Meeting Agenda

Historic Zoning Commission

Monday, March 10, 2025

② EXTERIOR ELEV // LEFT SIDE
1/4" = 1'-0"

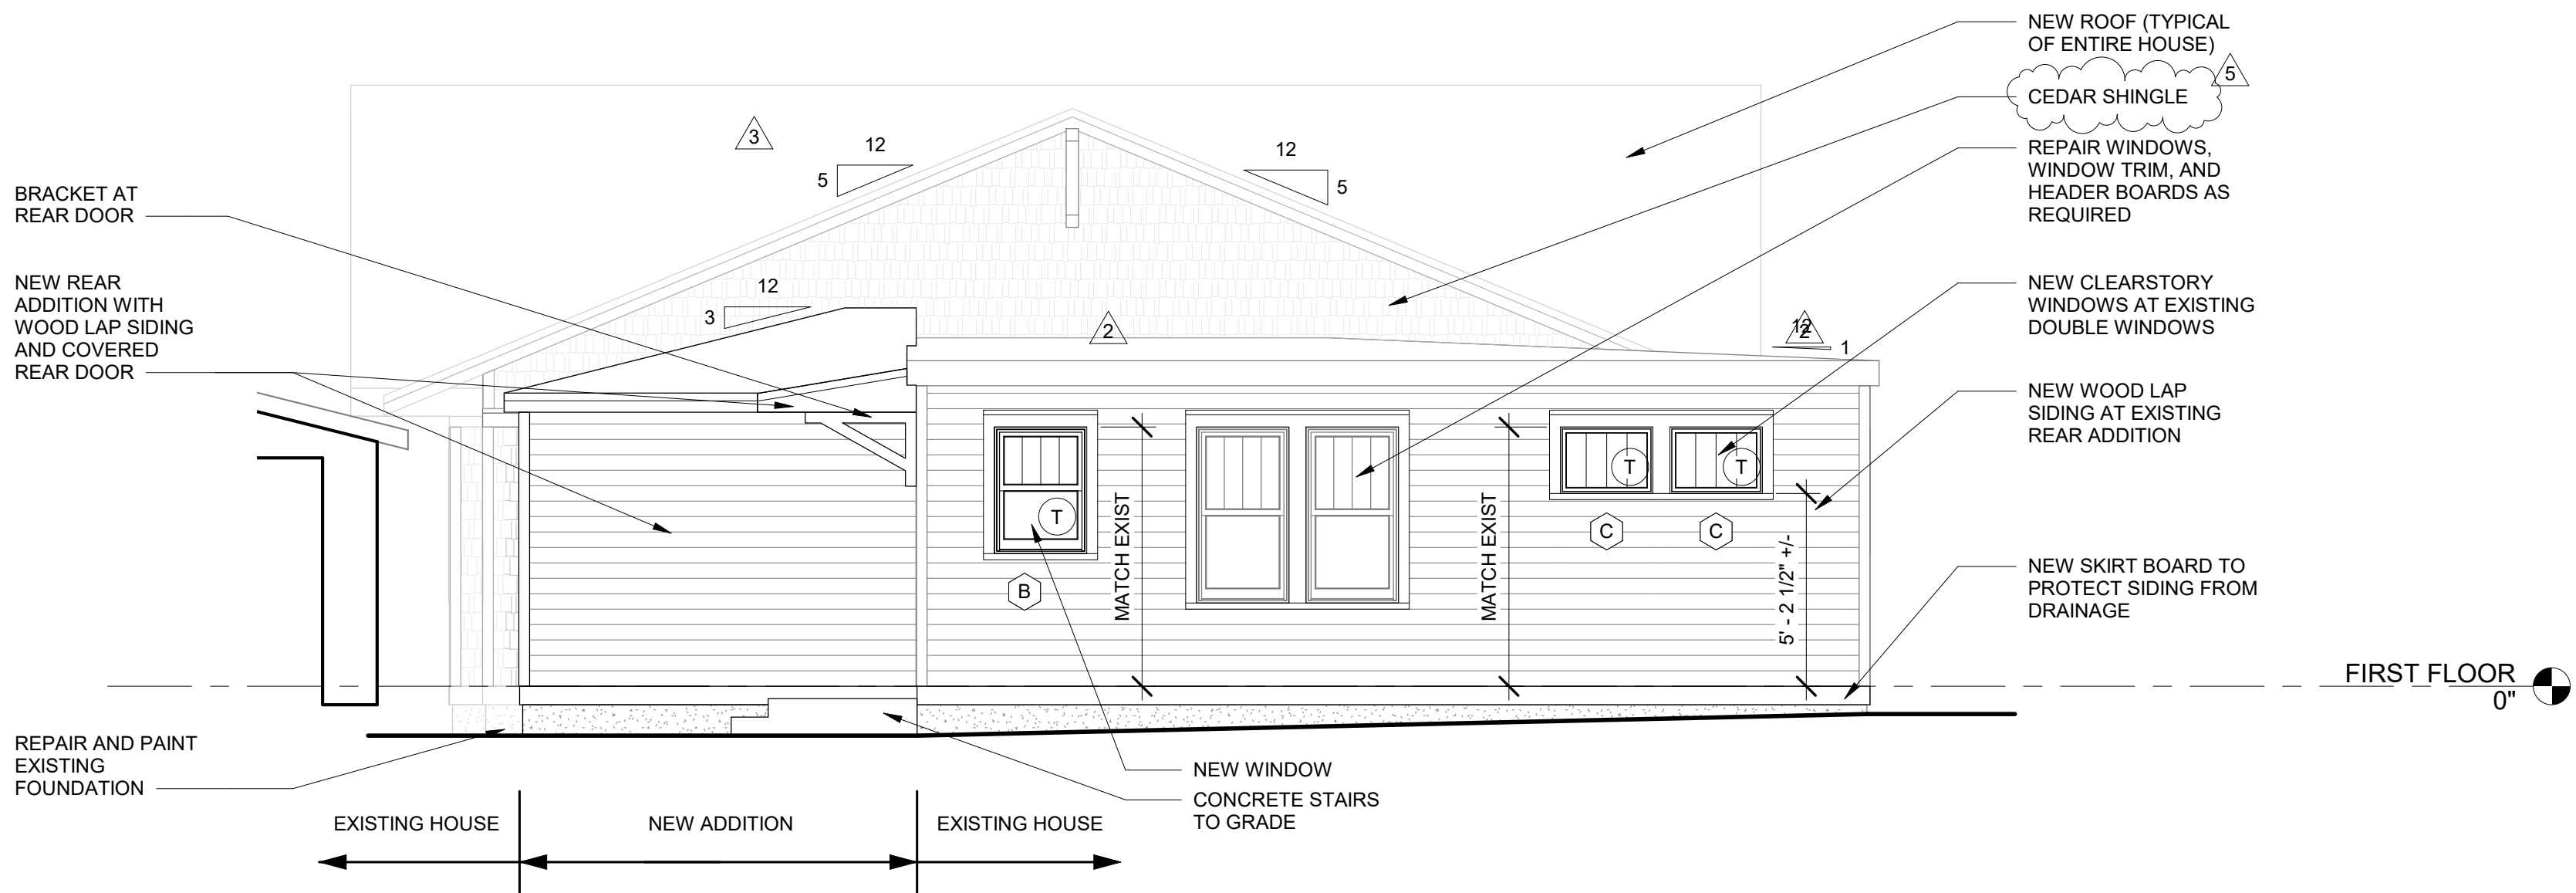
Included within the first COA issued in March of 2023, cedar shake was approved for the siding material on the entirety of the historic principal building and on the accessory structure. Cedar shingle was discovered to have been the siding material underneath the asbestos siding during initial work on the building. In November 2023, the proposal returned to the commission with alterations, including using lap siding for the building of cedar shake and stucco in the front gable end. In January 2024, the proposal returned for a change in material to the accessory structure to be clad in all lap siding and not cedar shake and was previously approved.

The reintroduction of a material that intends to match a historic material to the building is appropriate. The applicant has also provided example images of local homes of the same style and with the same material combination. The change in material in the gable from the previously approved lap siding to cedar shingle is appropriate.

Awning Proposal

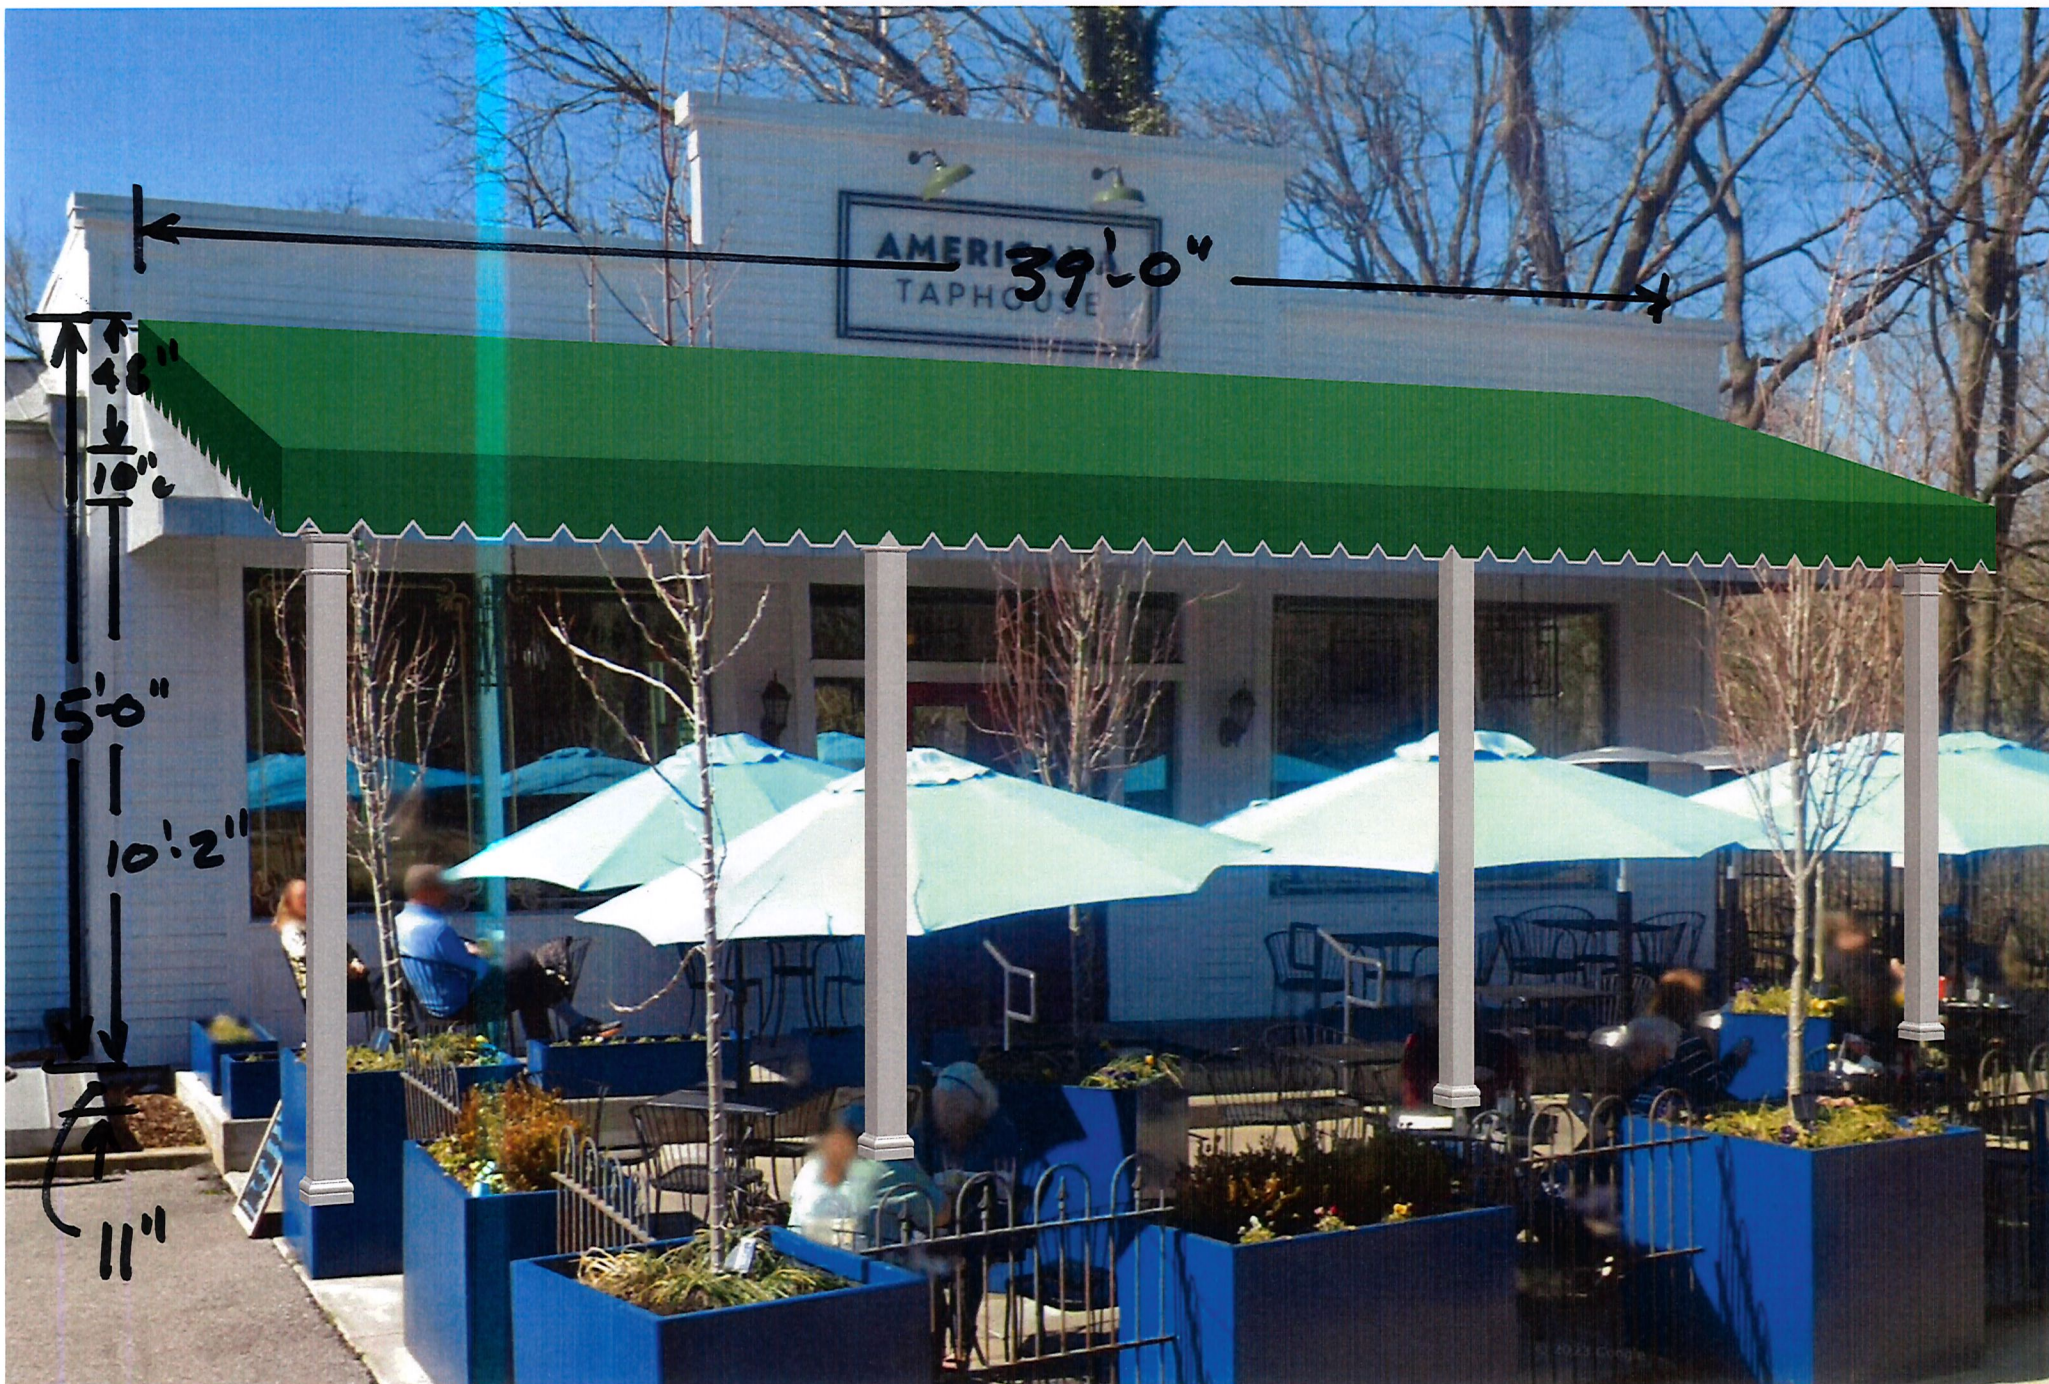
The proposed awning will be green in color, and is 39 ft x 8.5 ft projection, with 4 steel posts installed.
